Addendum No. 3, June 11, 2025

Re: Johnson Hall Renovation – PKG 3
Johnson Hall Renovation & Foster Demolition
Tennessee Technological University
SBC Project No. 364/011-04-2022CM

From: Upland Design Group, Inc.
P.O. Box 1026 (38557)
362 Industrial Blvd.
Crossville, TN 38555
Telephone (931) 484 7541
Fax (931) 484 2351

SECOND FLOOR RENOVATION - DIMENSIONS

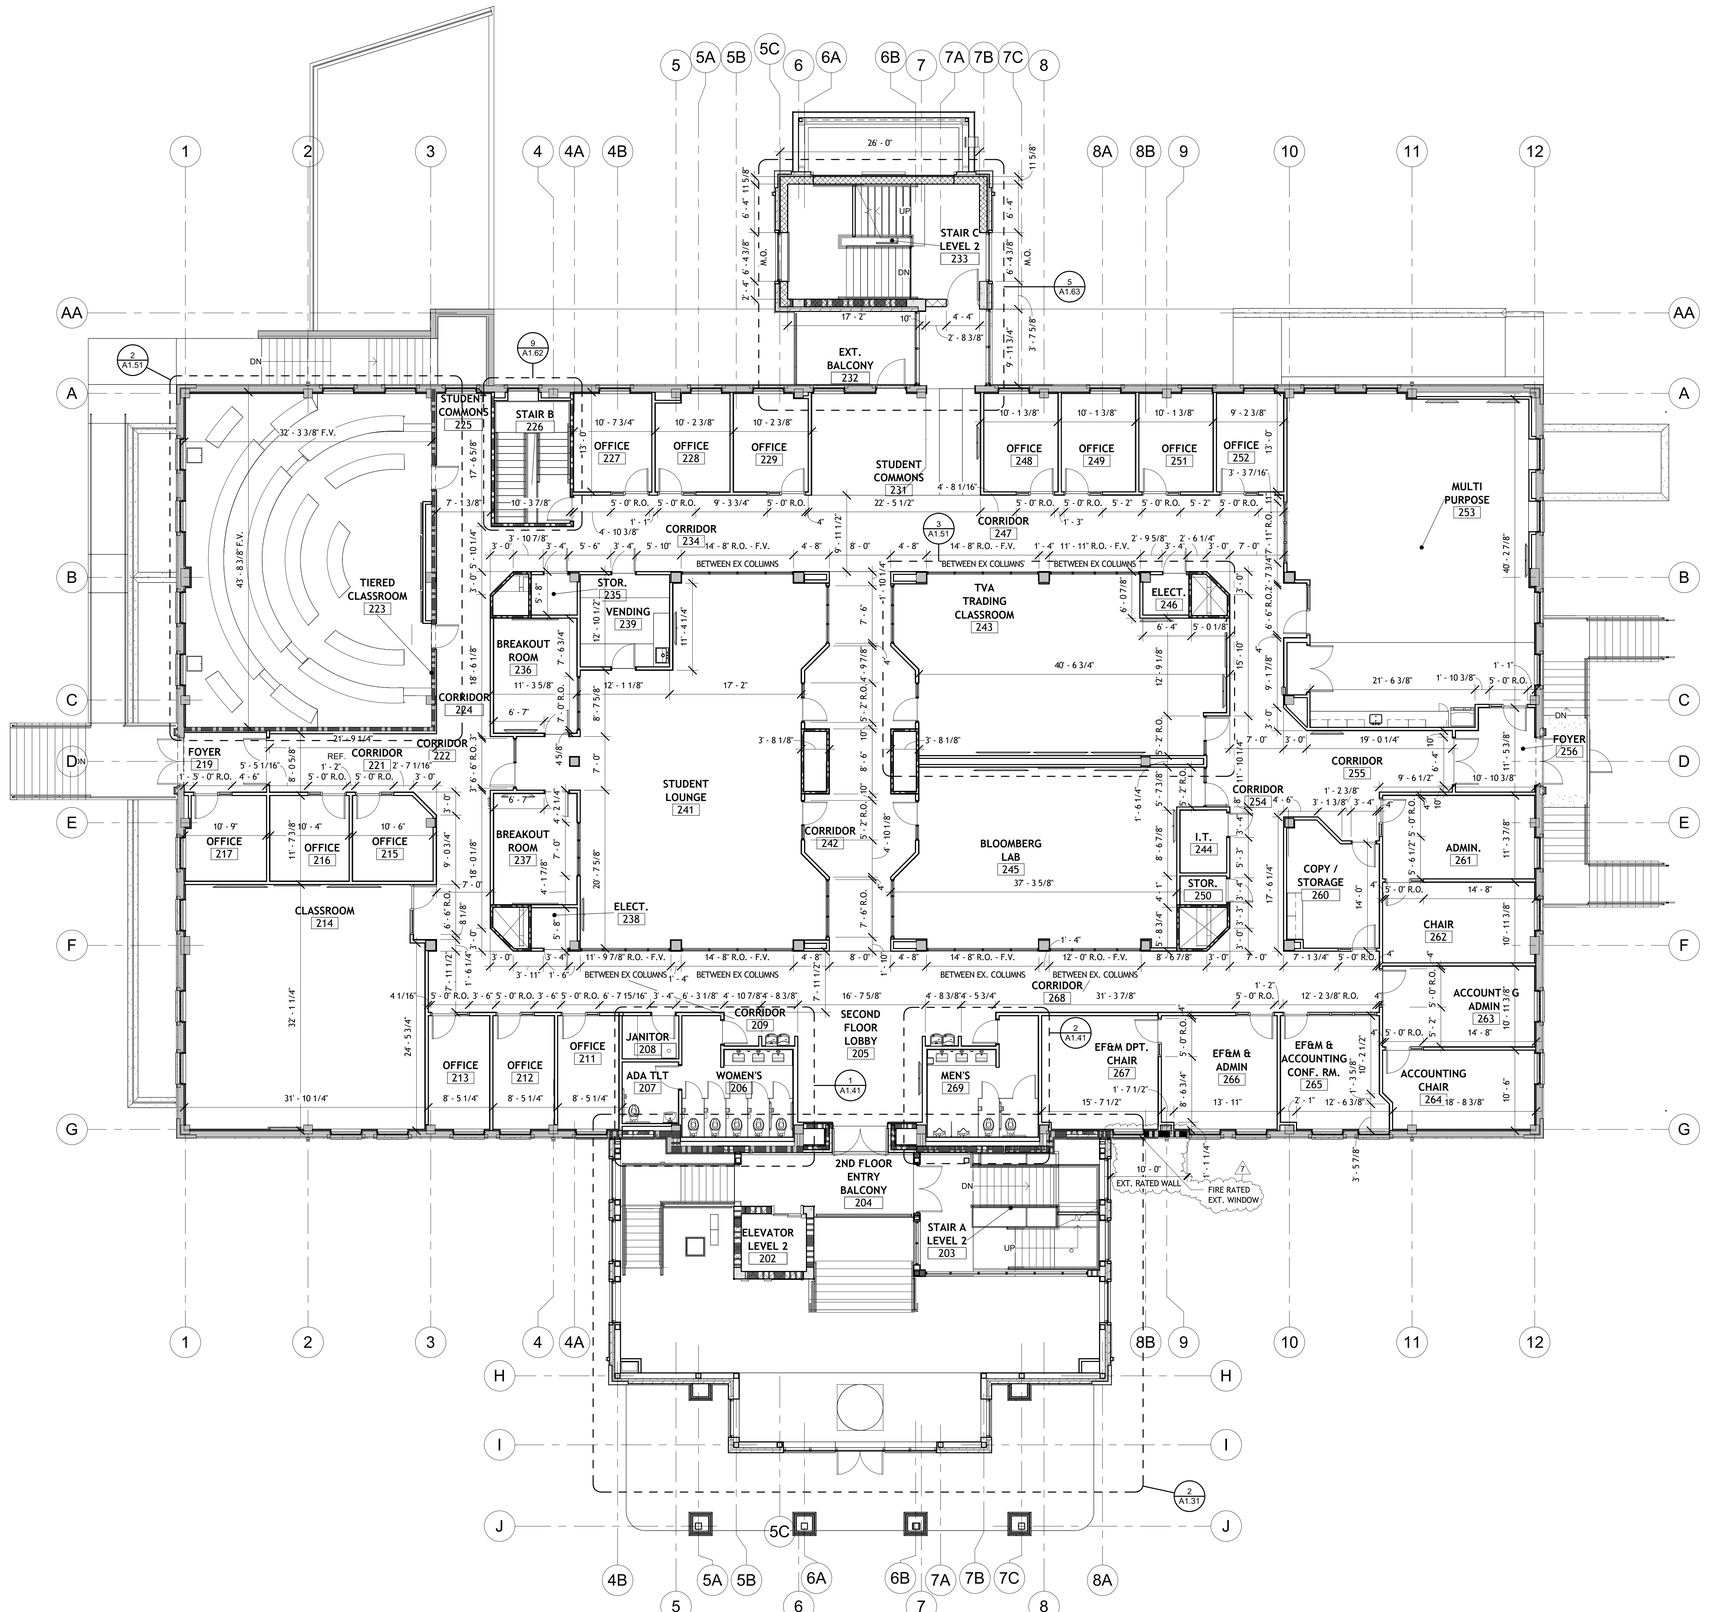
17) Refer to sheets A1.1D, A1.1N, A1.2D, A1.2N, A1.3D, A1.3N, A1.21, A1.22, A1.23, A1.31, A1.32, A1.61, A3.01, A7.10, A7.20, and A7.30. Add 1-hour fire rating to the first 10 feet of the plan east side of the new lobby addition per the attached revised sheets.

STAIR NOSING DETAIL 1

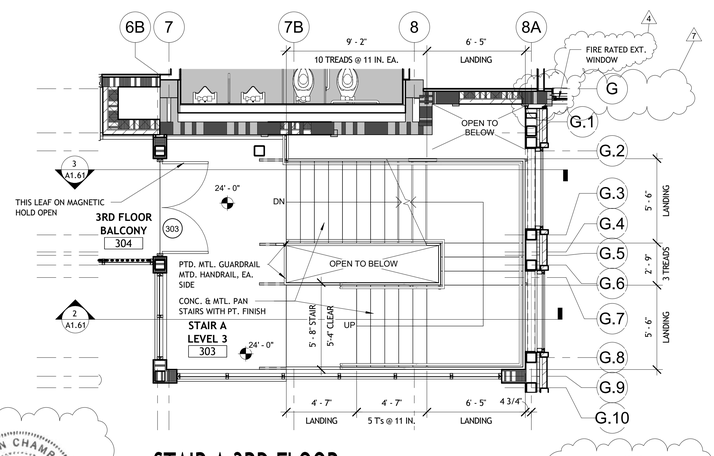
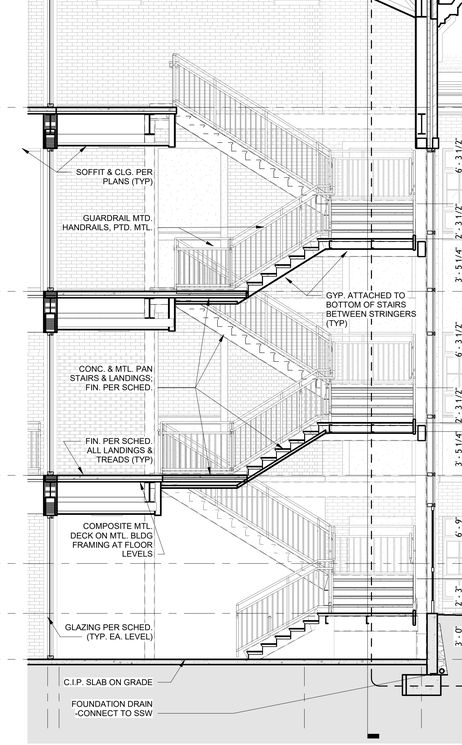
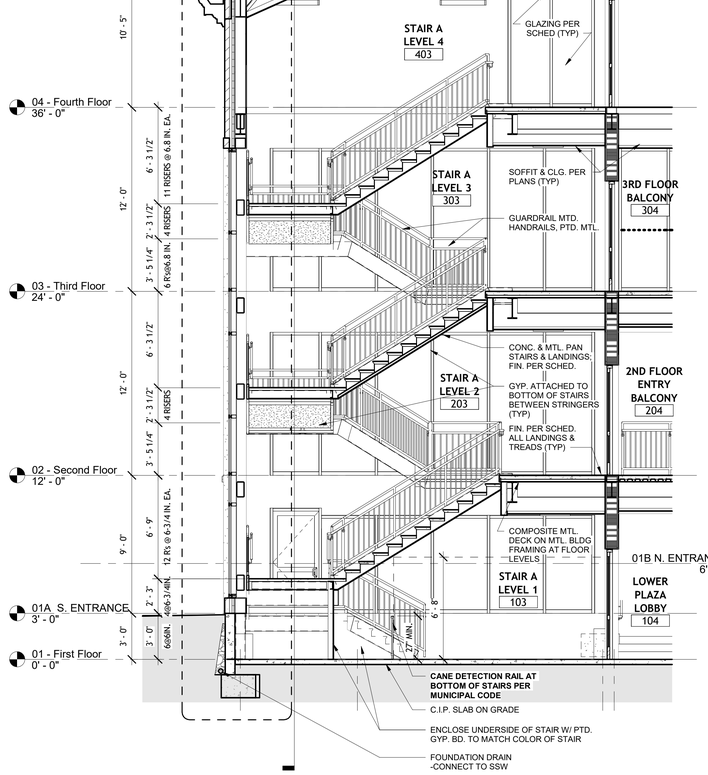
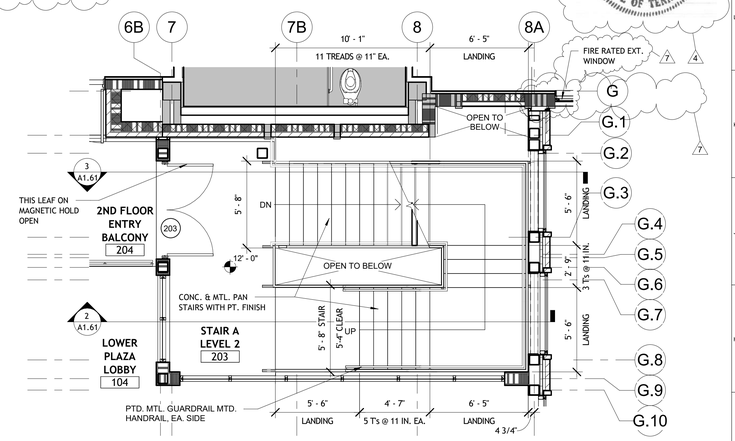
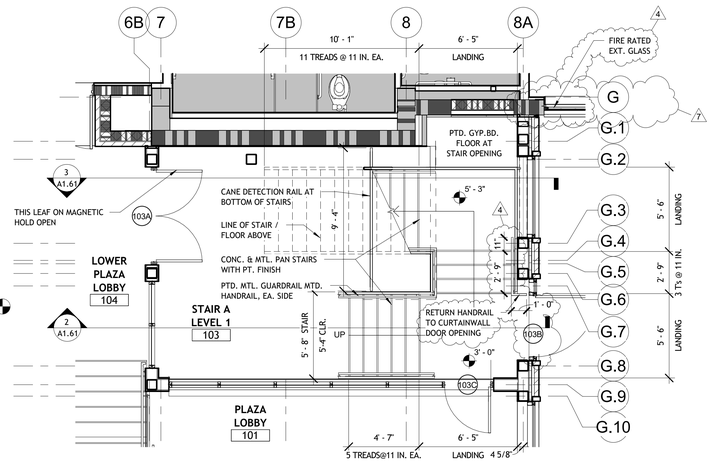
4) In Stair A and Stair D where there is a hard tile finish on the stair treads, use a Schluter Trep-E profile for the nosing edge and a Schluter-Dilex-BWA at locations where the tile abuts the steel stringer and risers.

A3.01

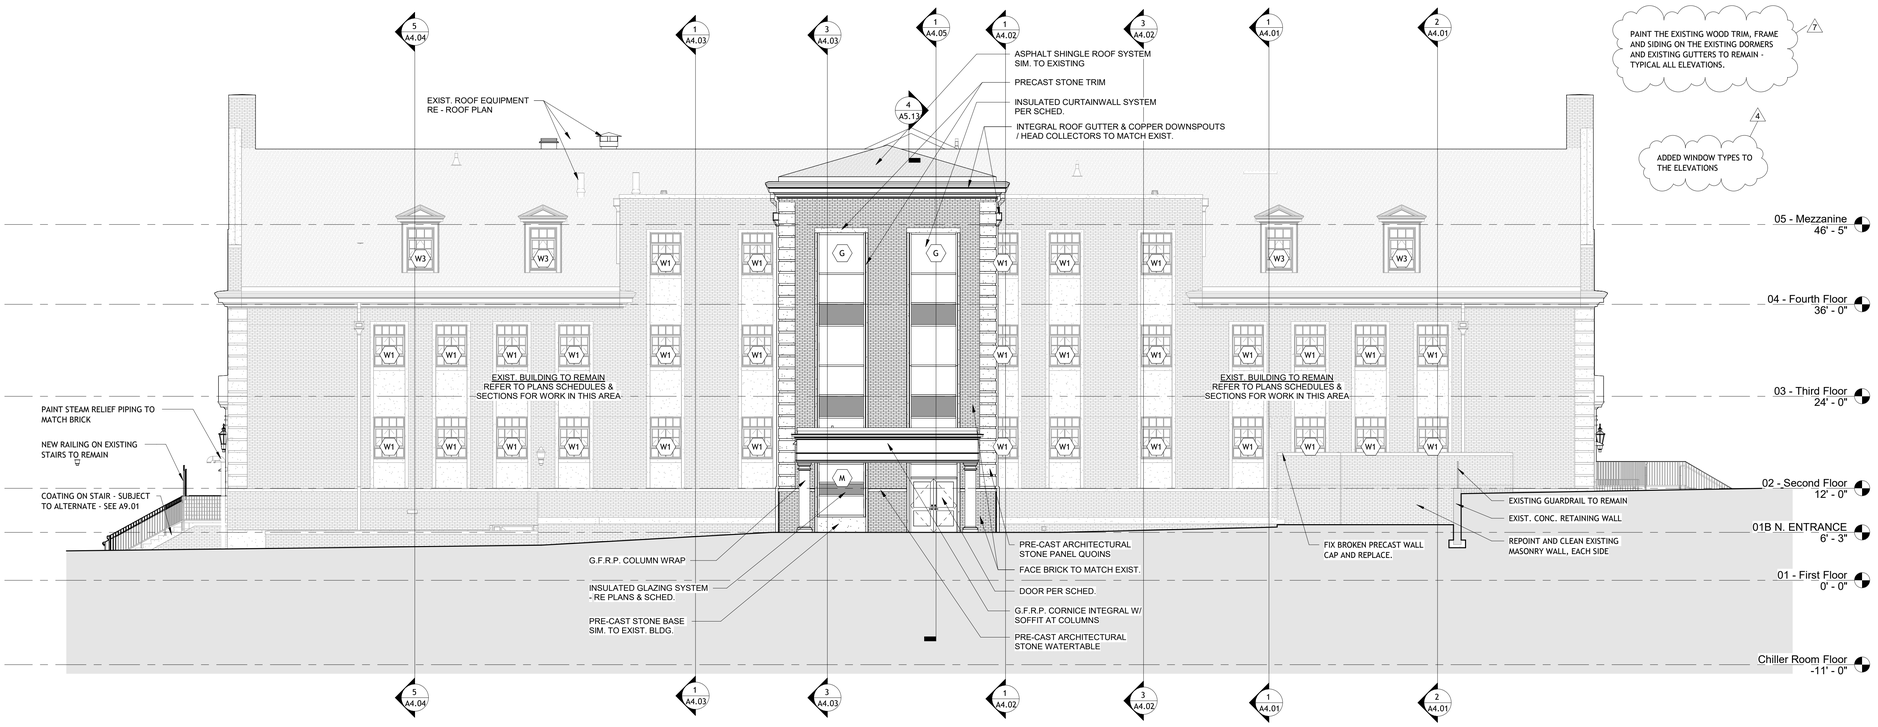
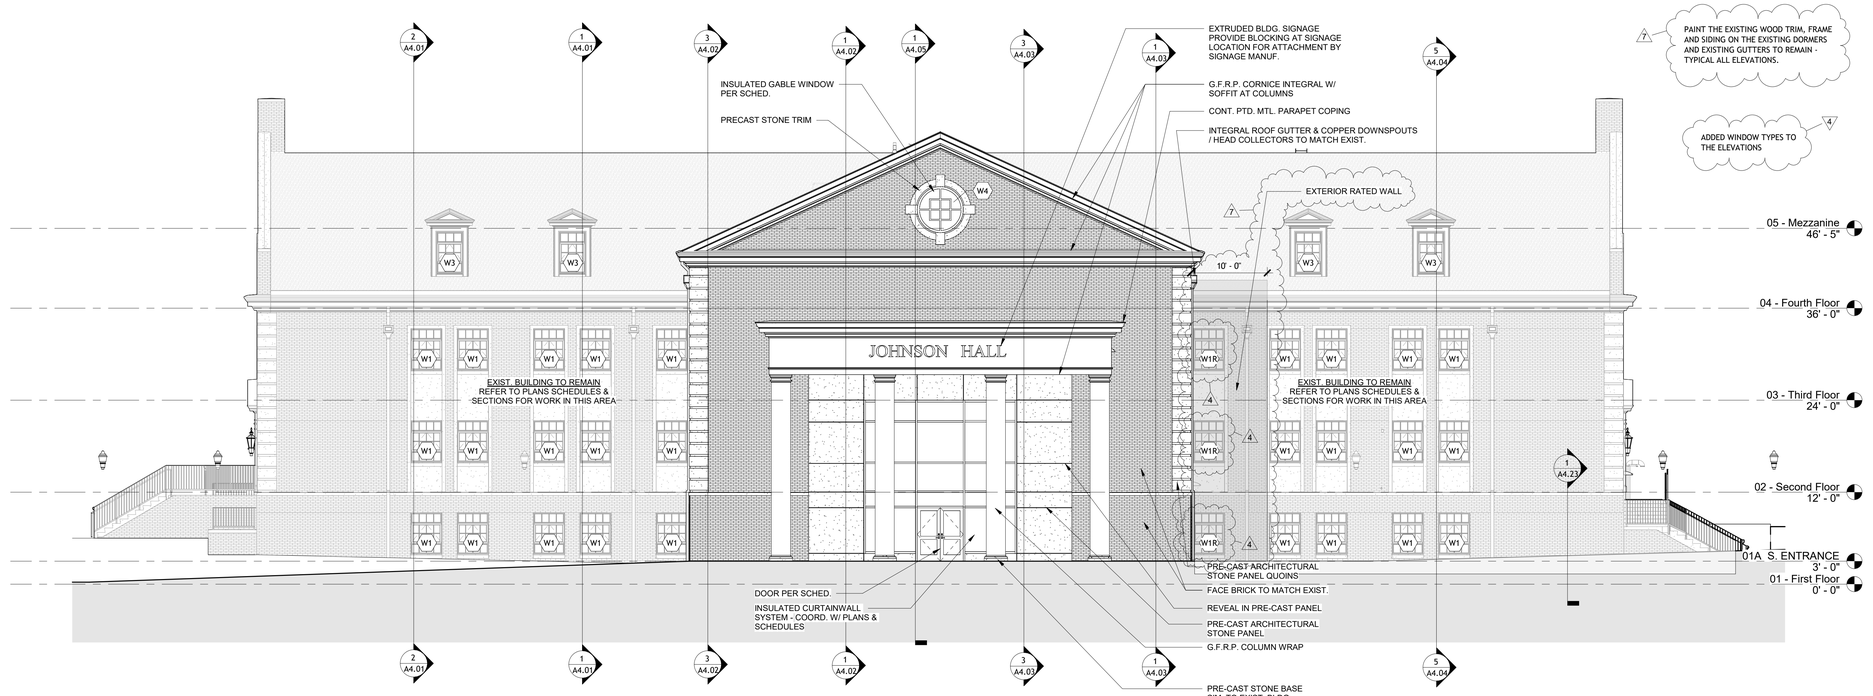
23) Refer to sheets A3.01 Exterior Elevations and A3.02 Exterior Elevations. Add the general note “Paint the existing wood trim, frame and siding on the existing dormers and existing gutters to remain – typical all elevations” to all elevations.
